Re: Draft Western Sydney Aerotropolis Plan

SUBMISSION TO THE EXHIBITION OF DRAFT WESTERN SYDNEY AEROTROPOLIS PLAN AND RELATED DOCUMENTS

**By
BBC Consulting Planners
with inputs from Cardno, Arcadis and at&I**

Diagram 1: University’s Land – WSAP Impacts

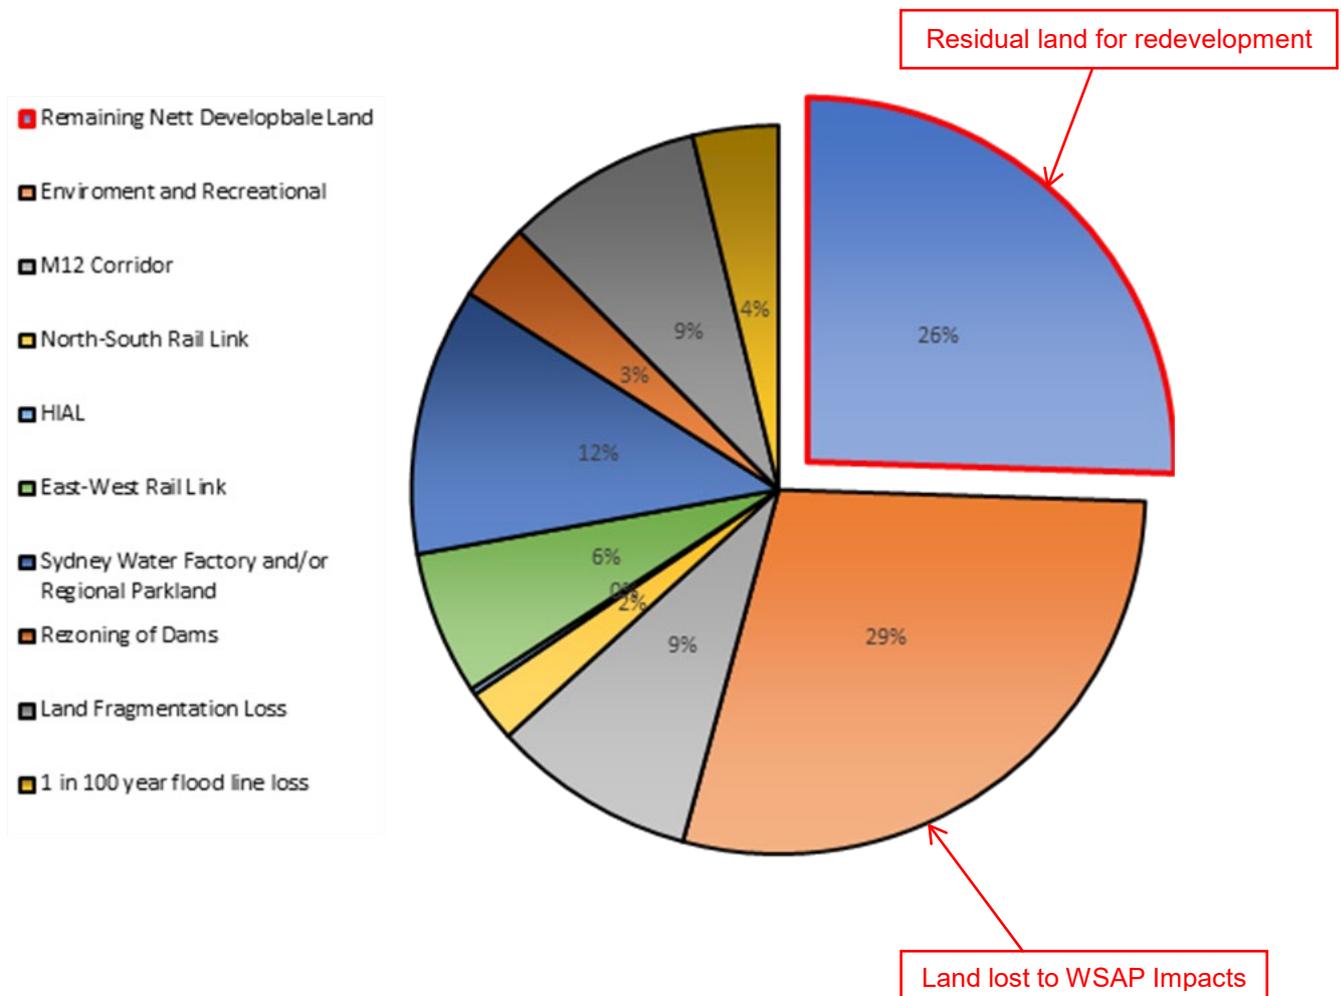
As highlighted in Diagram 1 below, the **88 hectares** of remaining land on the Property that is residual for redevelopment represents just **26%** of the entire Property – this is a significant reduction in developable land within the Property.

Figure 3 South Creek and Kemps Creek Roughness Zones (after Worley Parsons, 2015)

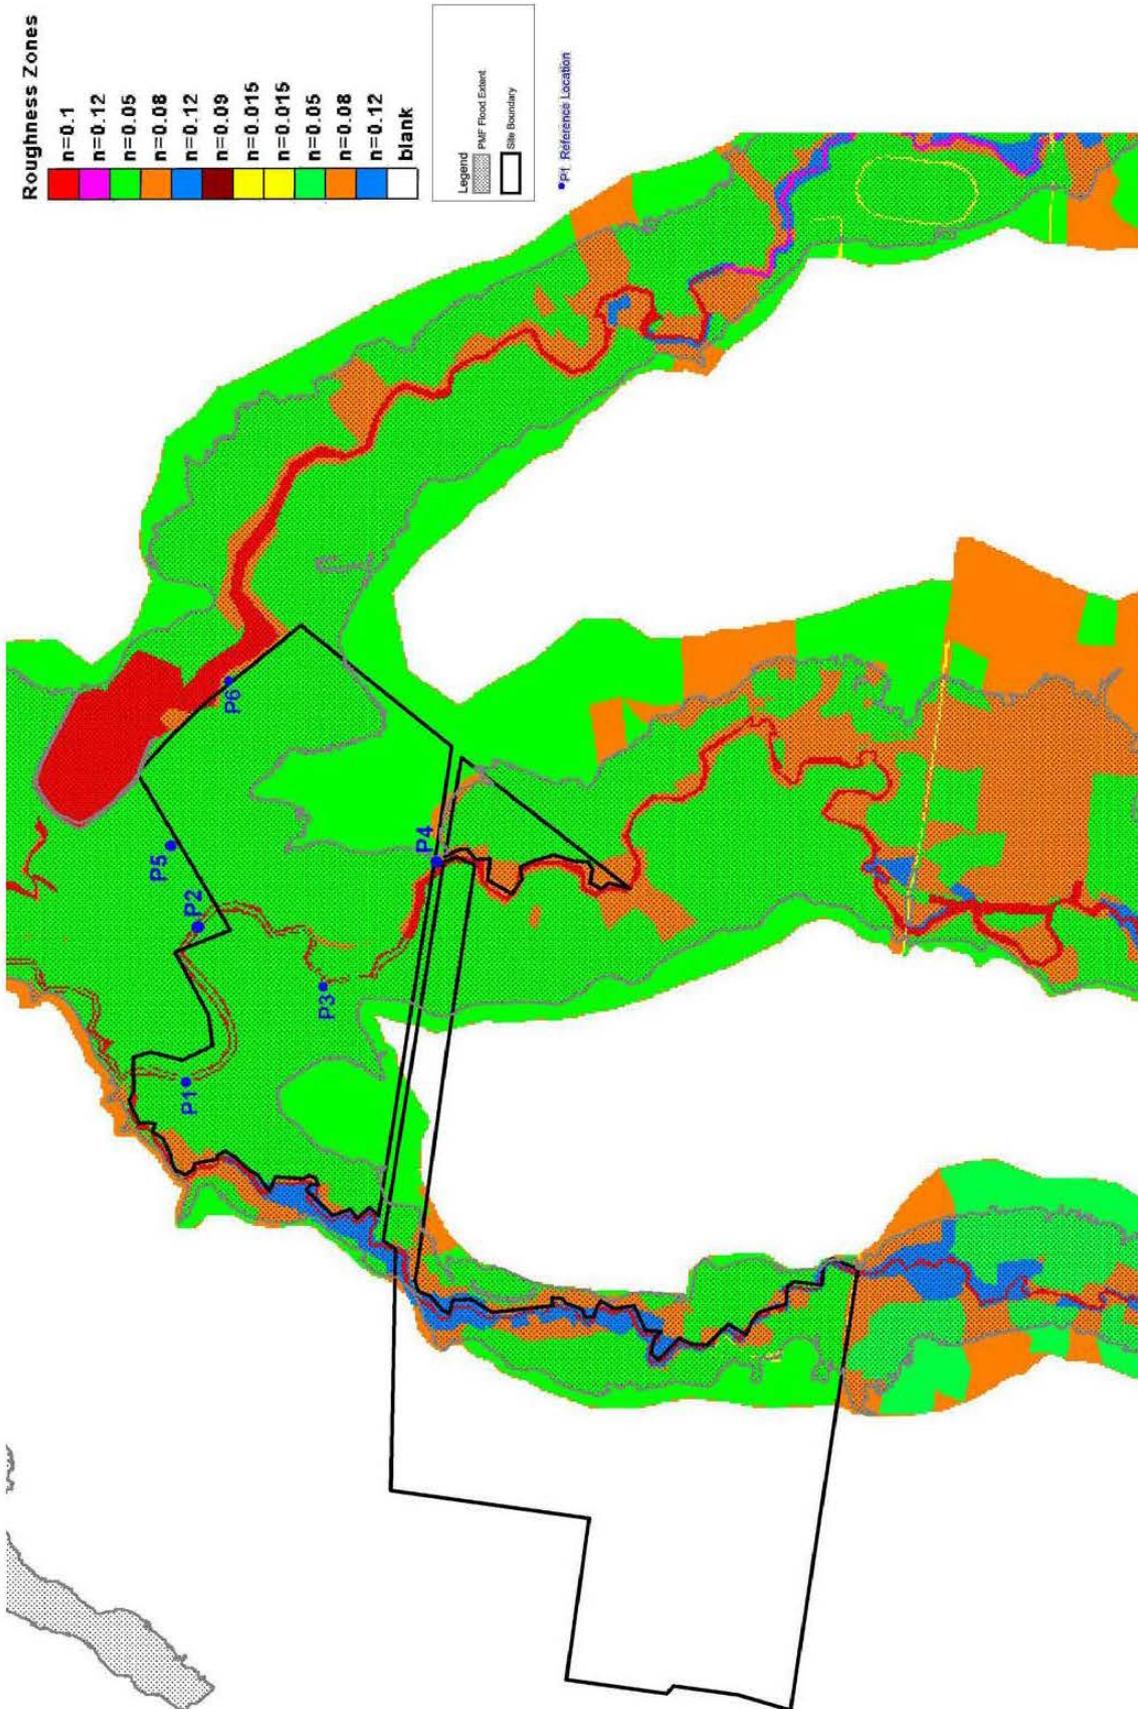
Figure 3 provides an overlay of the property boundary and indicative PMF flood extents over a map of the roughness zones adopted for flood modelling purposes in the 2015 study. It will be noted that substantial areas of the floodplain inundated within the PMF extents are mapped as “Grassed floodplain and sparse trees” ($n = 0.05$). If the vision is to revegetate the corridor, then this revegetation could have a substantial adverse impact (increase) on flood levels in the 1% AEP flood and the PMF.

The results are given in **Table 1** of the indicative assessment at six reference locations on South Creek and its floodplain within the property boundary which are identified in **Figure 3**.

Figure 4 South Creek Flood Risk Precincts (based on results from Worley Parsons, 2015)

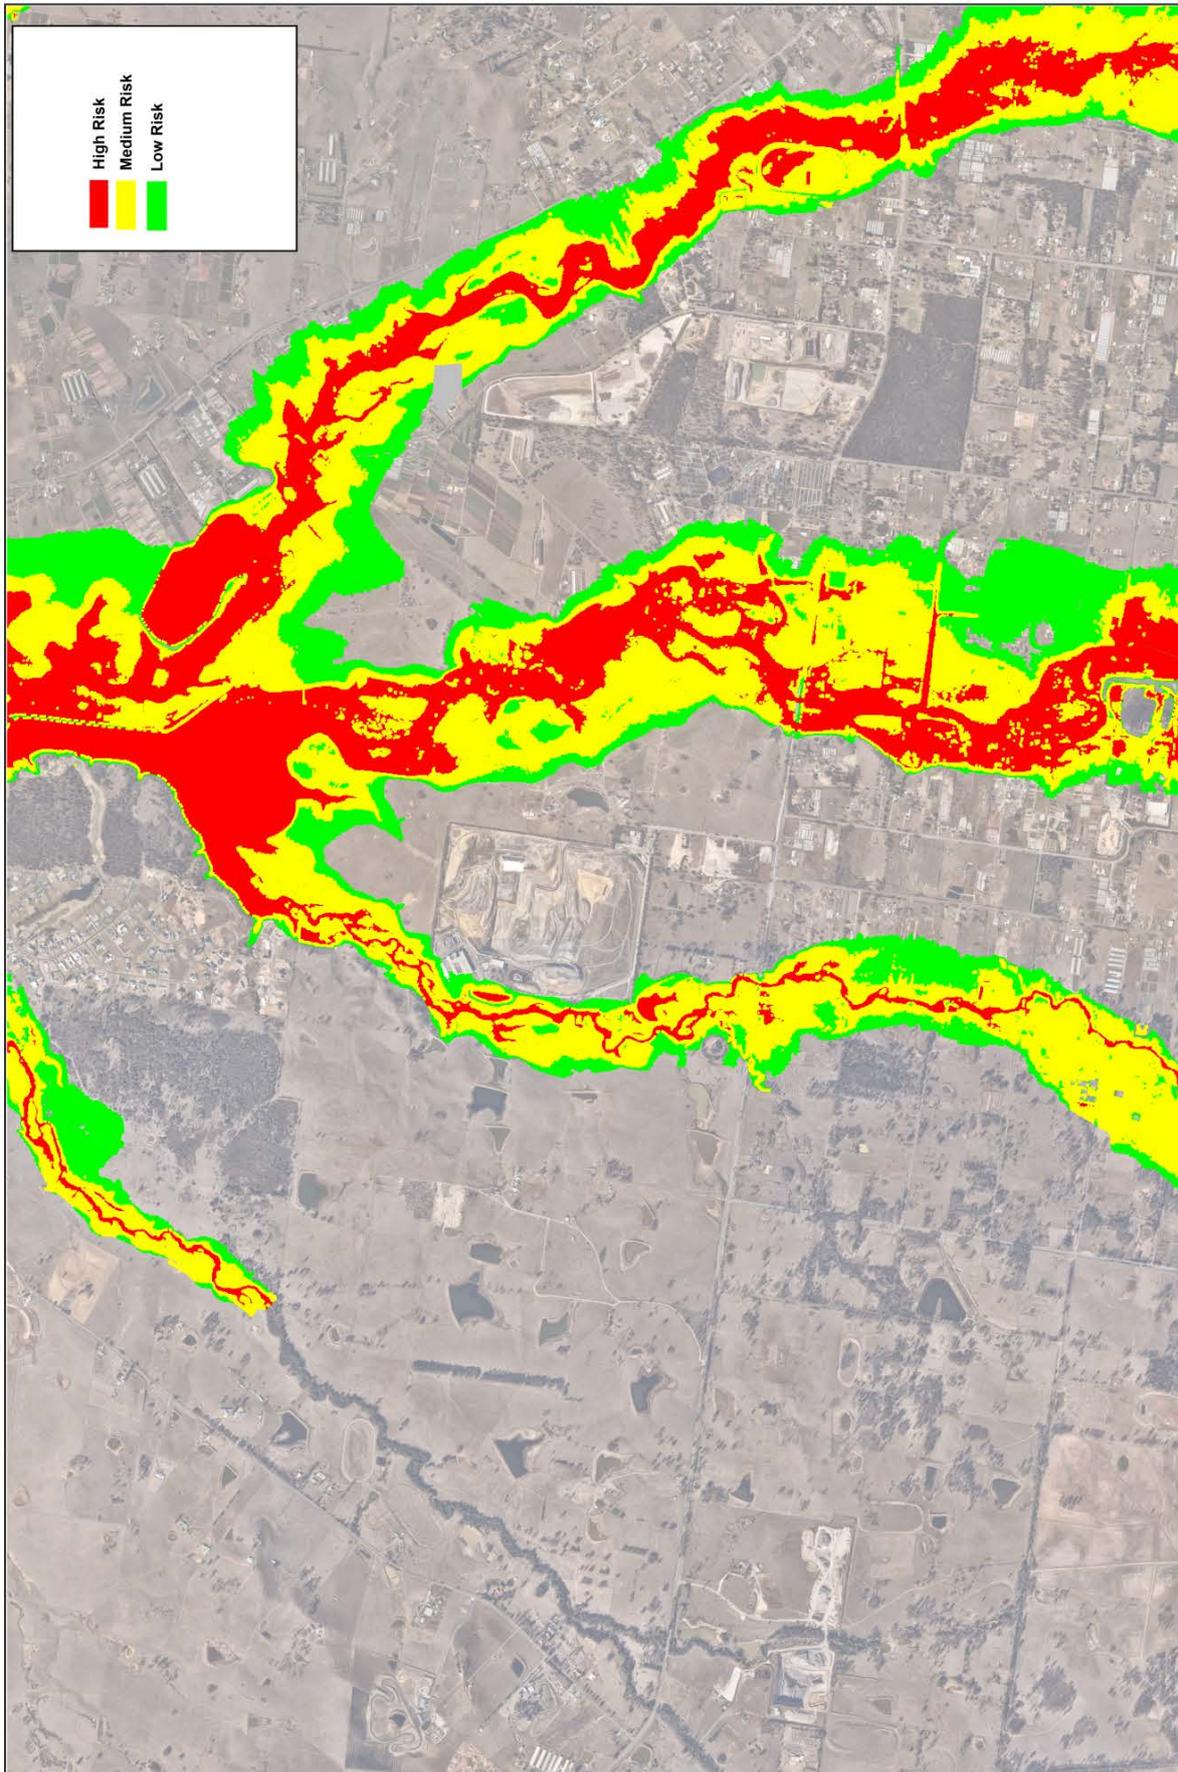
Instead the already established planning matrix approach and development controls adopted by Liverpool City Council which is based on flood risk precincts should be adopted. This approach is outlined in Appendix B.2 and is codified in the Liverpool DCP 2008 Part 1, Section 9 Flooding Risk. The extents of the flood risk precincts in the vicinity of the University of Sydney Western Lands mapped from the results of the 2015 South Creek flood study are plotted in **Figure 4**.

**Figure B.1 Flood Emergency Response Planning Communities North of Elizabeth Drive
(after Figure G.14, Advisian, 2019)**

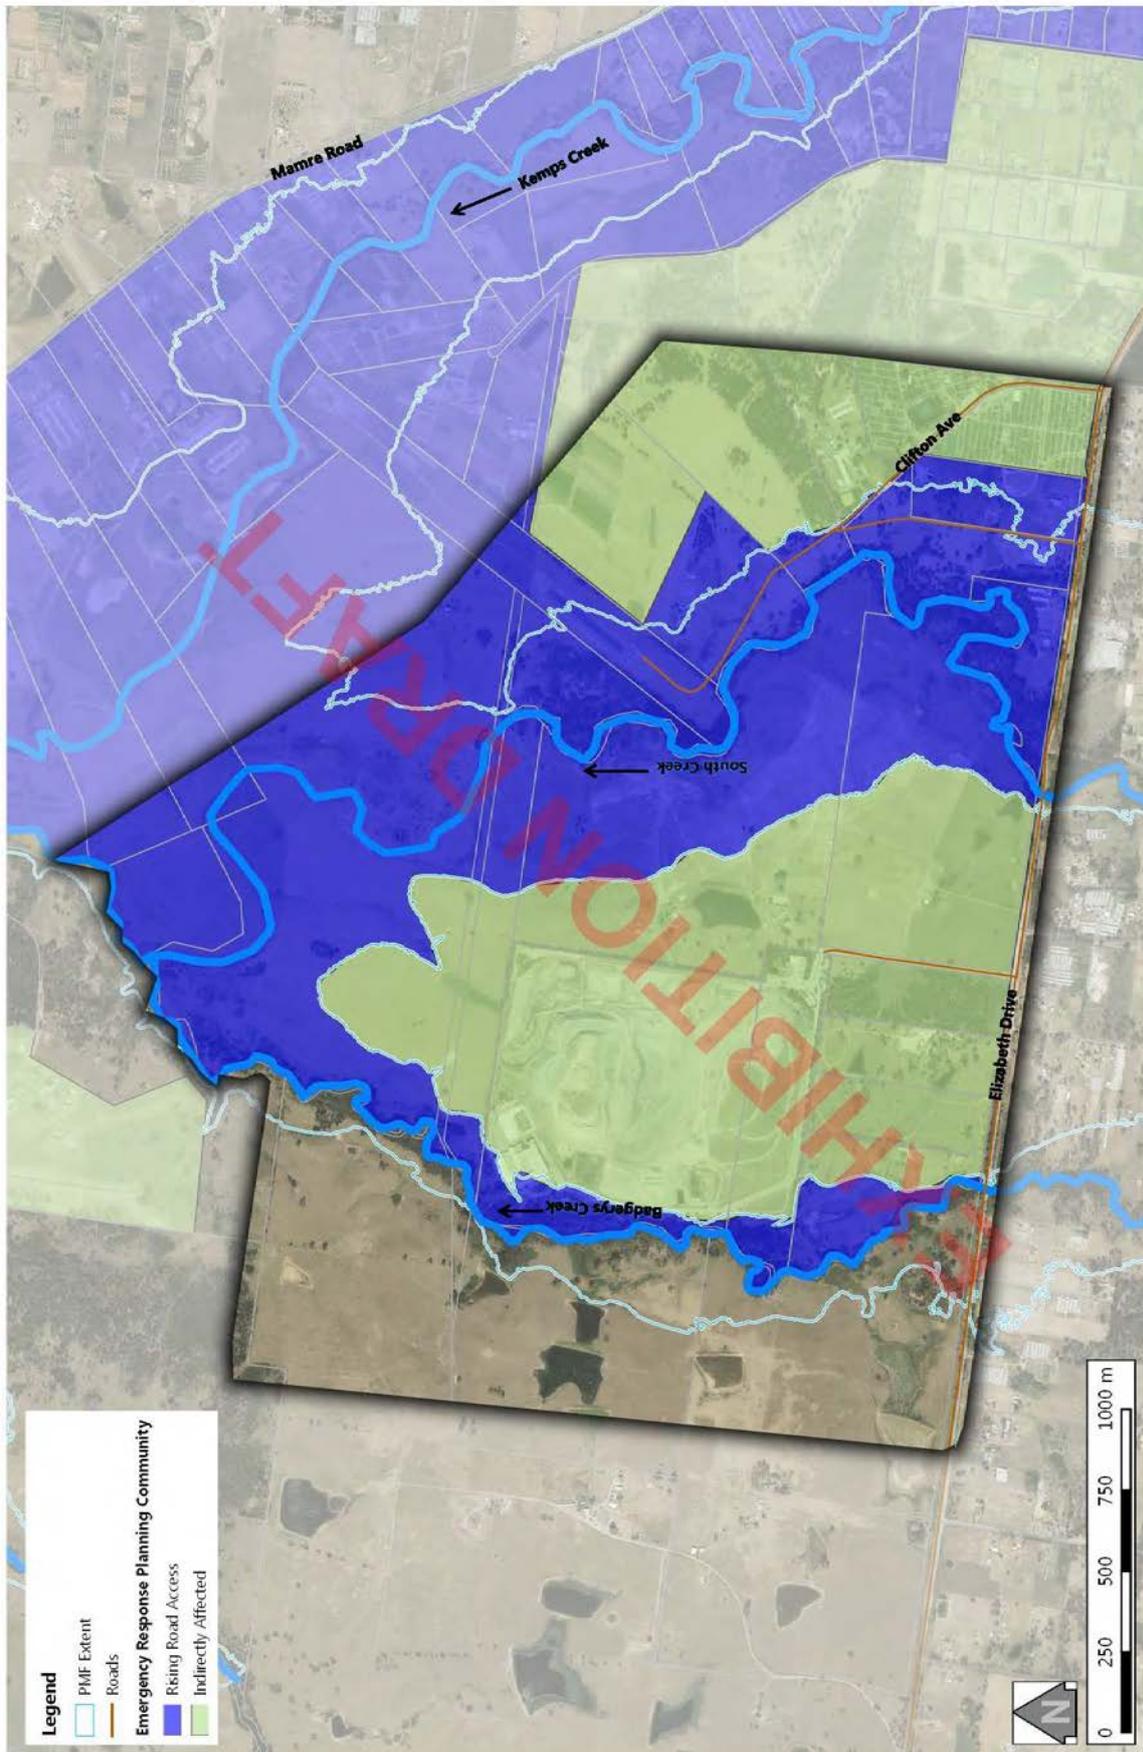
The mapping of the land north of Elizabeth Drive is reproduced in **Figure 2**. It is classified as either Rising Road Access or Indirectly Affected Area.

A review of the Penrith Development Control Plan (DCP) 2014 led to the following recommendations:

- *Updateable annexures be added to the DCP to include 'True Flood Hazard Mapping' and 'Hydraulic Category Mapping' prepared as part of the FRMS;*
- *Future Floodplain Risk Management Studies for watercourses within the Penrith LGA be required to prepare Flood Planning Constraints Category (FPCC) mapping similar to the FPCC prepared for South Creek and included as Appendix D. Once FPCC mapping is available for the LGA, it is recommended that DCP controls be updated to ensure development is guided by the FPCC mapping.*

- *Amendments to the DCP be made to update development controls relating to:*
 - *Extensions to existing development,*
 - *Change of use, and*
 - *Rural Development*
- *Development controls be revised relating to the assessment of flood impacts; and*
- *Additional clauses be added to the DCP relating to:*
 - *Critical facilities (e.g. schools, hospitals, aged care facilities, etc),*
 - *Requirements for flood impact assessments and flood risk assessments commensurate to the development size, type and flood risk, and*
 - *Climate change*
- *The format of the DCP be revised to set out different development types and flood risk into a matrix approach.*
